SERVICE BULLETIN

MODIFIED ROTARY VALVE COVER FOR ROTAX® ENGINE TYPE 582 UL SB-2ST-002

Modified rotary valve cover for ROTAX® engine type 582 UL

Bild / fig. 1

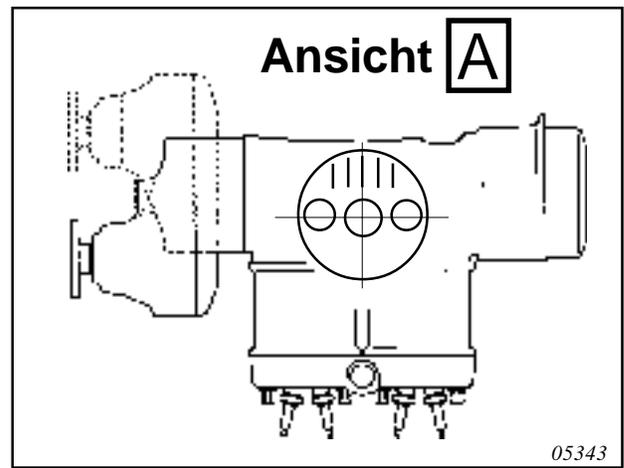
Combination of engine installation and engine version as described in chapter 1.1 could result in accumulation of fuel in the rotary valve cover. By abrupt changes of the engine position (e.g. aircraft at take-off) the accumulated fuel can be drawn in via the intake - port resulting in short engine RPM drops due to momentary rich mixture.

- Drill a 0.118 in dia. (drill size - # - 32) hole (see fig. 1 item 2) through the rotary valve cover (see fig. 1 and 2 item 1).
- Chamfer the bore by 0.02 in x 45° (see fig. 2 item 2) on the rotary valve side and deburr completely.
- ◆ NOTE: Thoroughly clean chips and emulsion after machining operation from the rotary valve cover (see fig. 1 item 1).
